ENVIRONMENTAL REVIEW TEAM REPORT
ON
BEAR SWAMP ROAD SUBDIVISION
EAST HAMPTON, CONNECTICUT
JULY, 1976

ENVIRONMENTAL REVIEW TEAM REPORT
ON
BEAR SWAMP ROAD SUBDIVISION
EAST HAMPTON, CONNECTICUT

The Eastern Connecticut Environmental Review Team was asked to review approximately 177 acres of land for which a single-family home subdivision is proposed. The site is located east of Pocotopaug Lake and Route 66, and the eastern site boundary follows a portion of the East Hampton/Marlborough town line.

**TOPOGRAPHY
AND
SURFICIAL GEOLOGY**

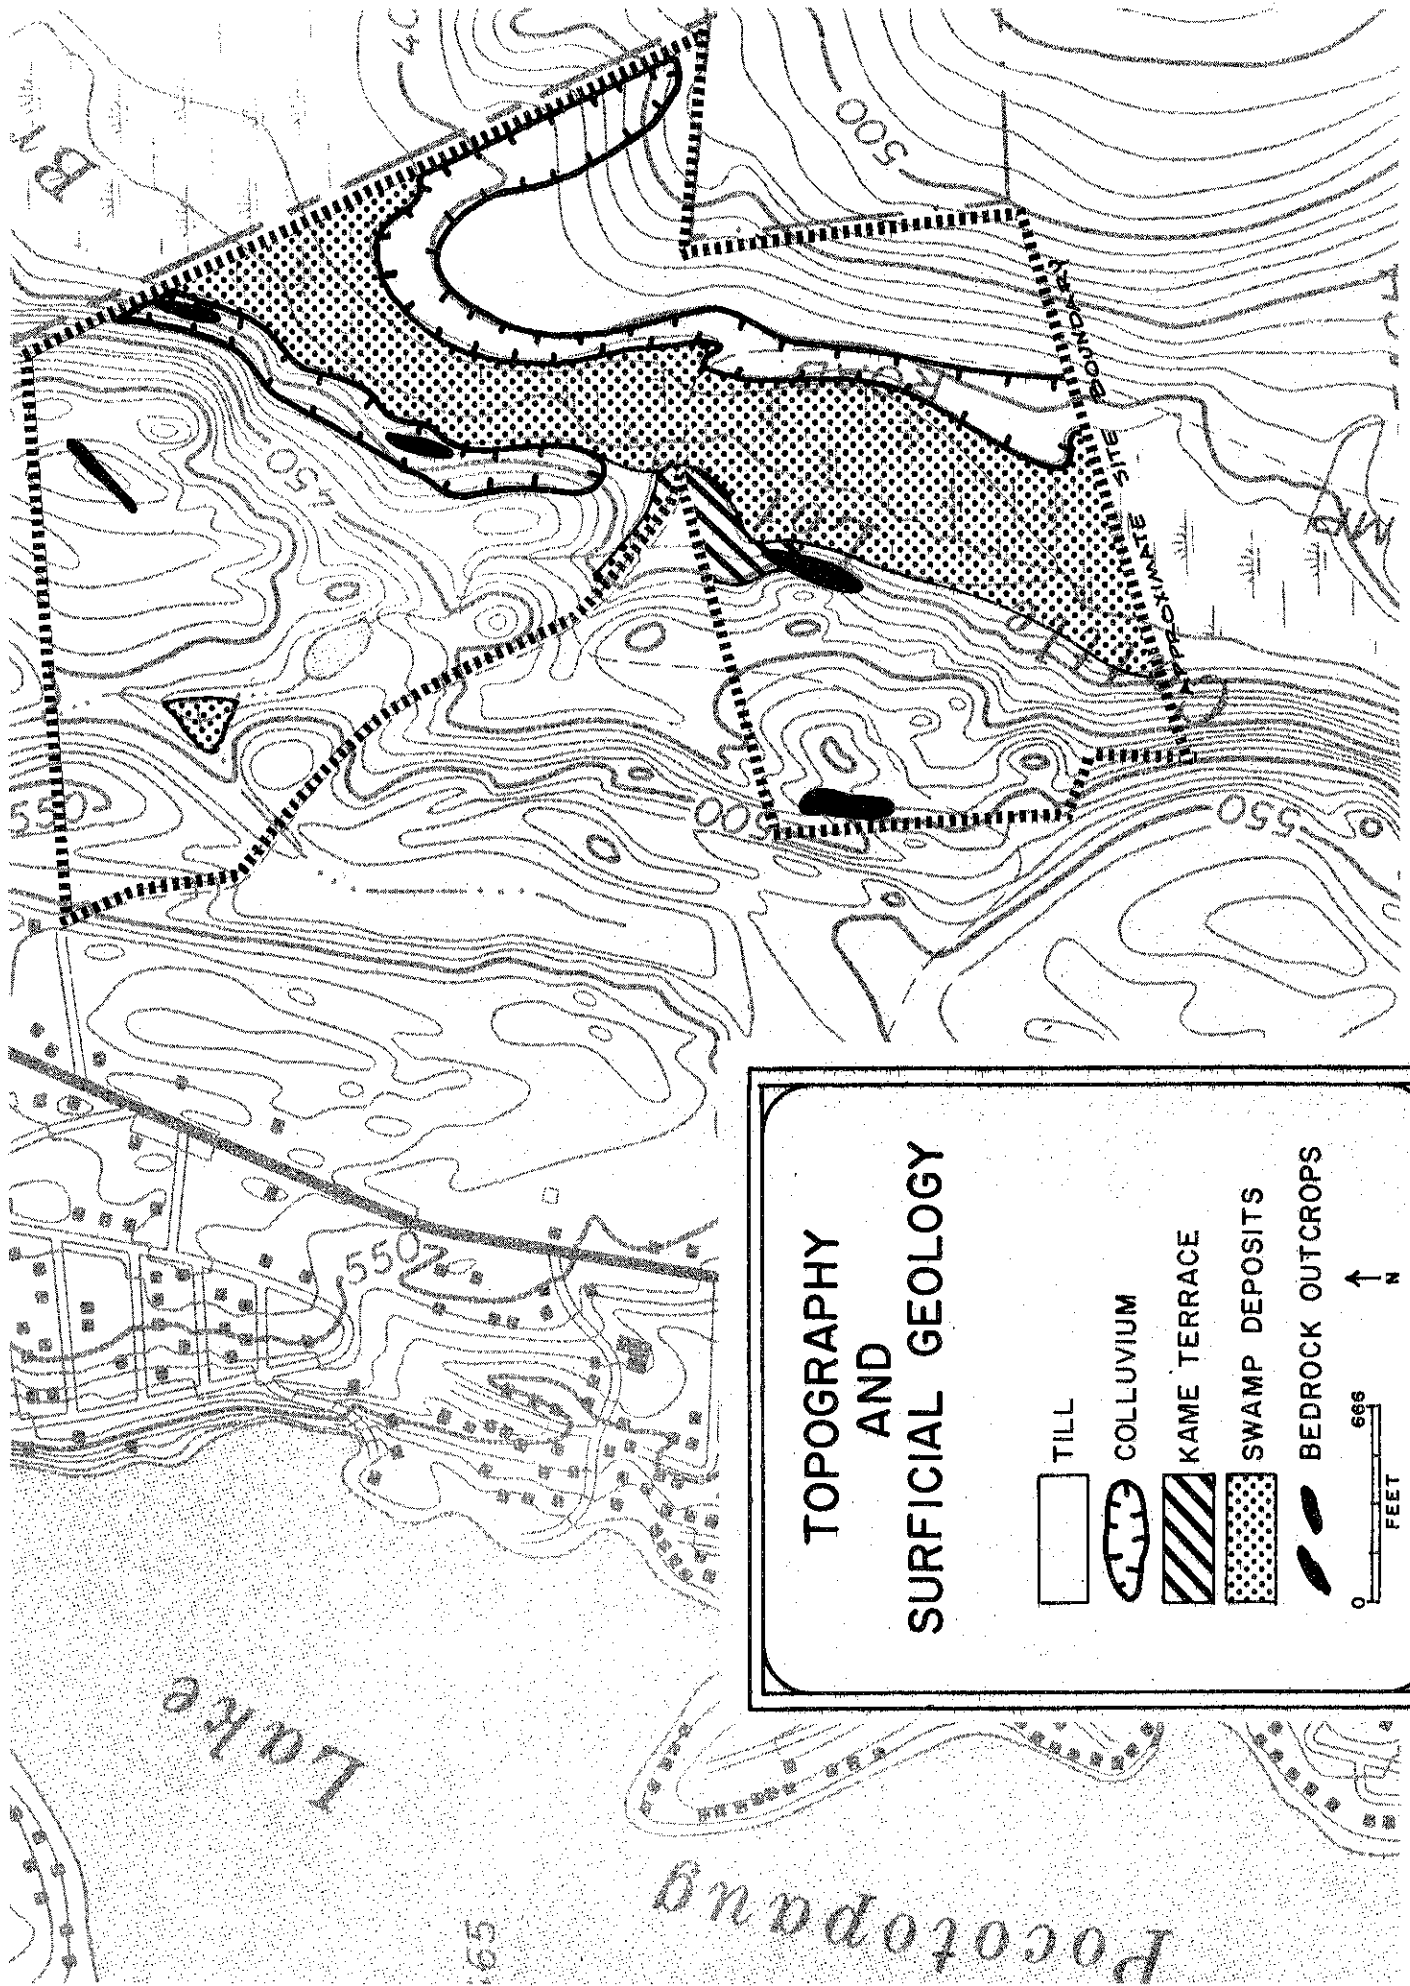
As indicated on the Topography and Surficial Geology Map, there are numerous outcrops located on the west side of Cattle Lot Brook. This area is extremely shallow to bedrock. The map only indicates areas of large outcroppings, many smaller ones were located during the field review. Although the shallow bedrock surface make excellent bases for foundations, they do create problems in design of subsurface sewage disposal and in the placement of onsite water supply wells. Possible further investigation may be needed when designing in shallow bedrock areas.

**FLOOD
PRONE
AREA**

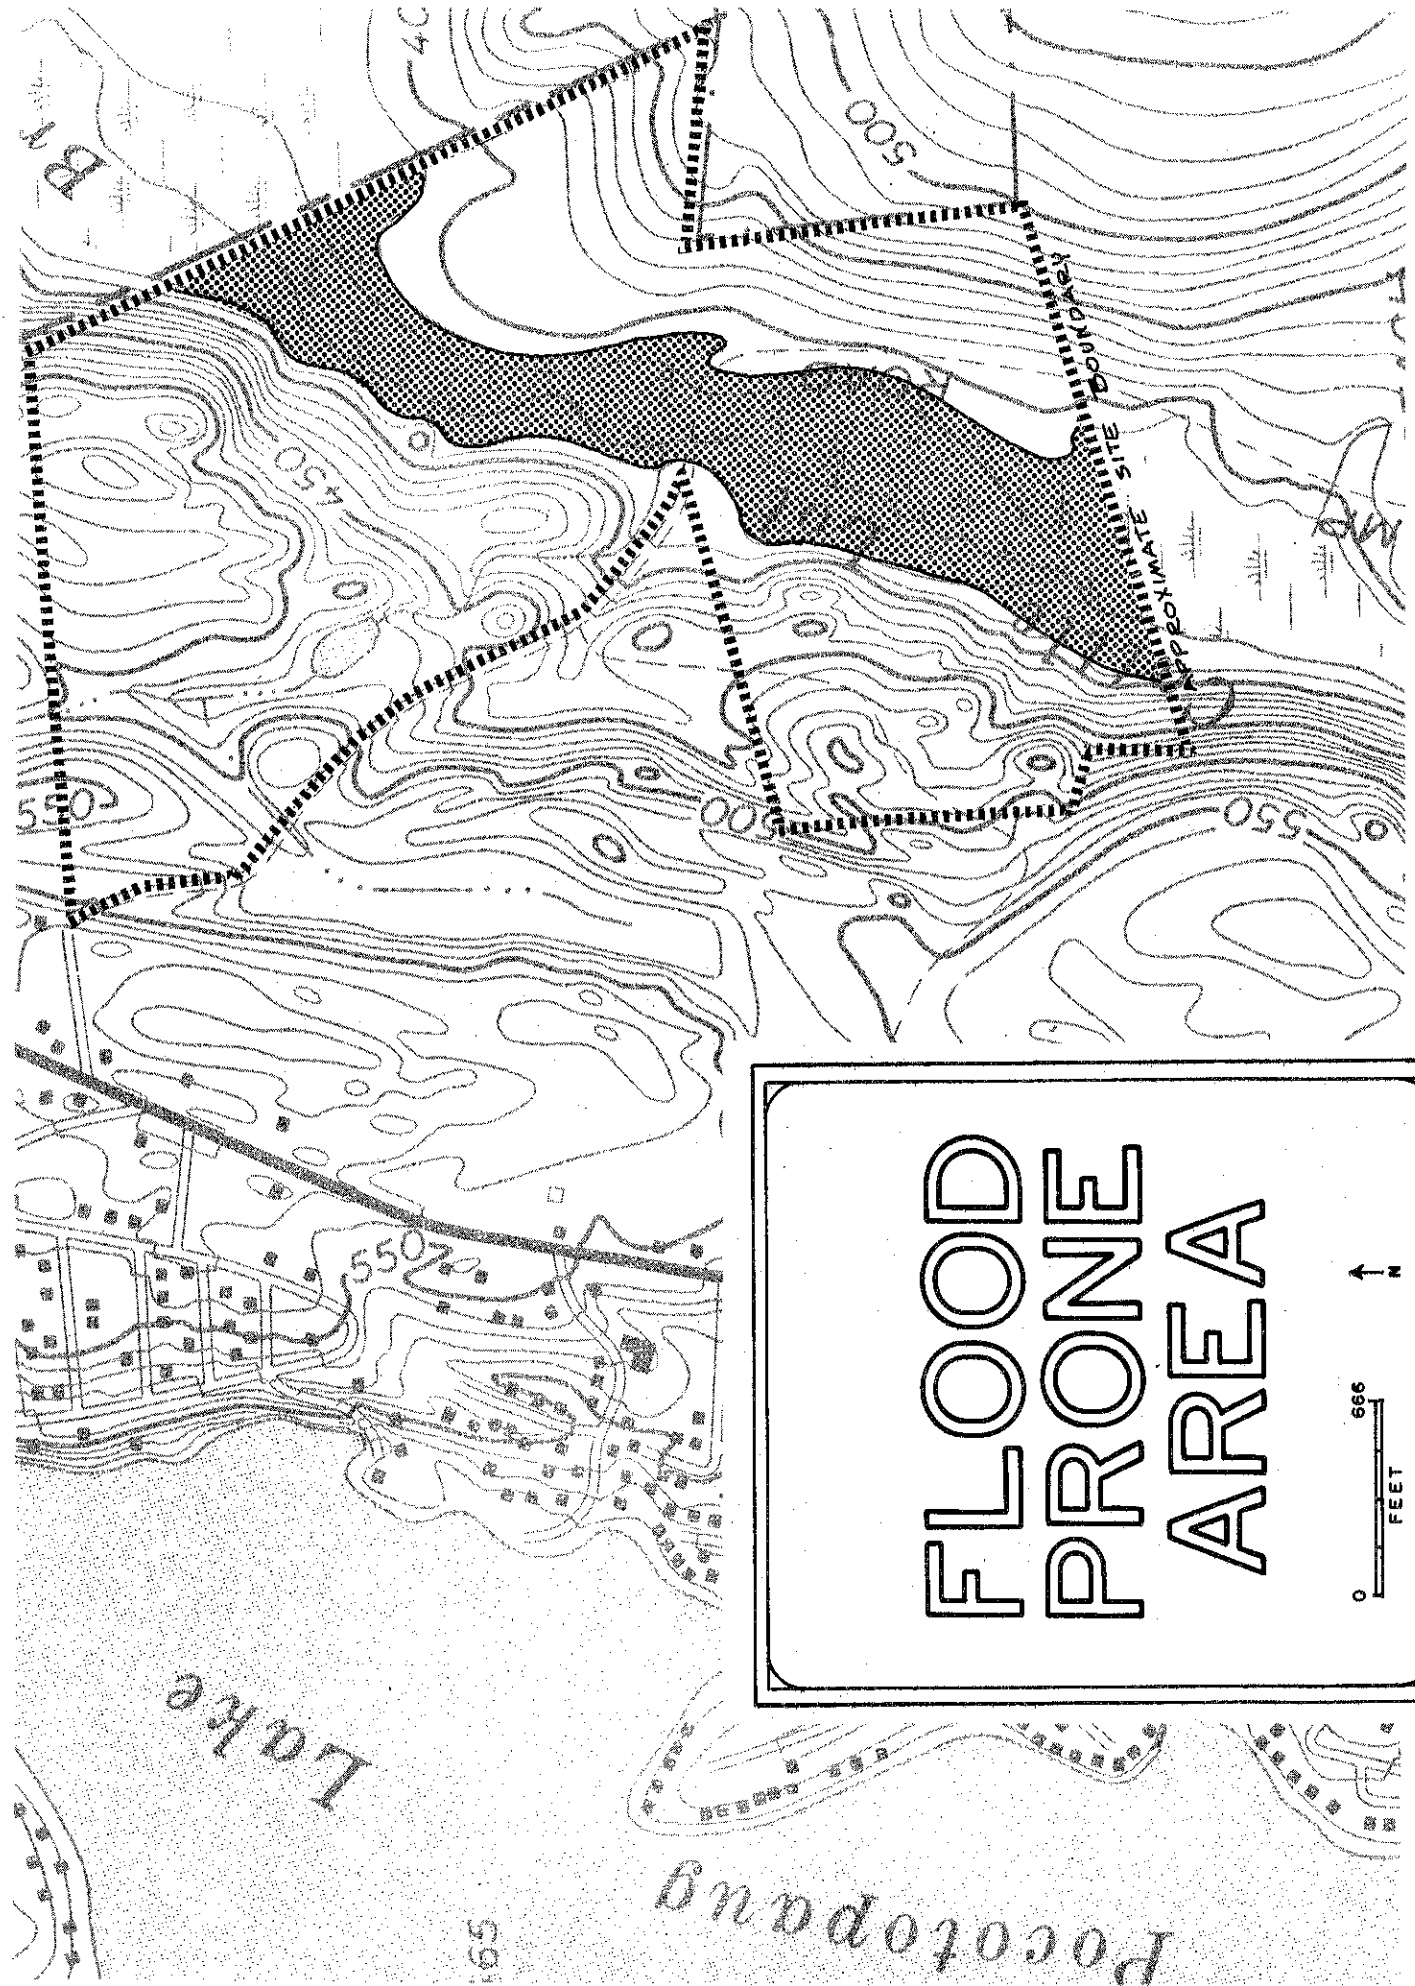
The site investigated lies approximately in the central portion of the Cattle Lot Brook drainage area. The area encloses approximately 2.0 square miles. The flow of Cattle Lot Brook is in a general northeast direction. The low flow value of the brook through the site was not calculated. This value should be investigated further though as any planned development around the wetland area may effect the low flow value. The extent of the area potentially subject to flooding is shown in the Flood Prone Area map. According to source material from the United States Geologic Survey (USGS), the area indicated as flood prone has a one in 100 years recurrence level, meaning that at least once in 100 years the flood water will probably reach the level indicated. Of course, it should also be noted that this is a statistical flood level and that the levels indicated can occur twice in one year or for two successive years or more. A study of soils types will give a good indication as to normal yearly flooding. For safety, the one in 100 years flood level should be used for all design plans.

SOIL MAP

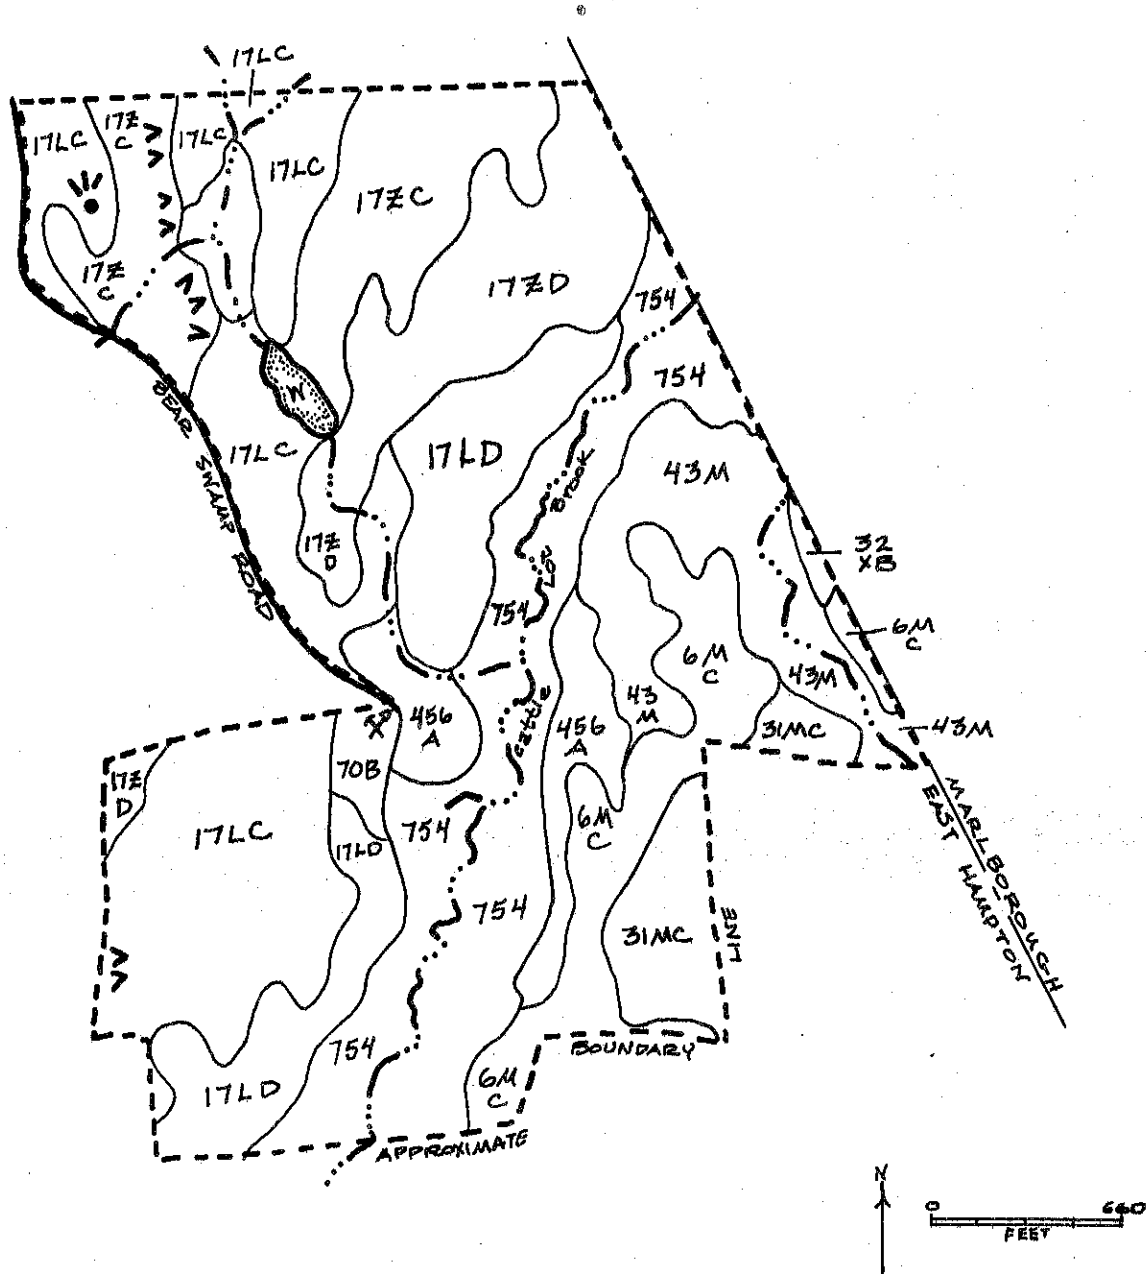
Referring to the soil map and soils limitations chart, approximately 98.5 acres are Hollis-Charlton or Hollis-Charlton outcrop soils characterized by steep slopes, bedrock outcrops, and a general shallow depth to bedrock. These soils

present severe limitations for on-site sewage disposal systems, basement construction, and other uses listed in the chart. The bedrock is typically less than two feet below the land surface, with numerous bedrock outcrops (exposed rock surfaces) as were observed during the field inspection. Due to the considerable amount of land having a shallow to bedrock condition, acceptable soil locations for septic systems should be determined before individual house lots are established on a site plan. Within these Hollis-Charlton soils it should be understood that there can be pockets of deep soil which, if found, can provide acceptable locations for development, probably individual house sites. These pockets can tend to be difficult and costly to locate, and may be widely spaced as the site contains areas of very steep slopes (greater than 15%) as well as a somewhat irregular topography in the northwest and southwest portions.

Approximately 52.5 acres of land around the major watercourses and intermittent streams of the site are wet soils such as Scarboro, Sudbury, and a Ridgebury and Whitman unit. The Scarboro (754), and Ridgebury and Whitman unit (43M) soils are very poorly drained. The water table in these soils is normally at or near the surface from late fall through late spring, but may drop below 6 feet during the summer months. It is advisable then not to take percolation tests in these soils during the summer months. The 43M soil is usually occupying low-lying nearly level to very gently sloping areas, while the 754 soil is usually found in low-lying flat or depressed areas. The Sudbury (456A) soil is moderately well drained, however, mottling appears at 14 to 20 inches in depth indicating waterlogging in wet seasons.
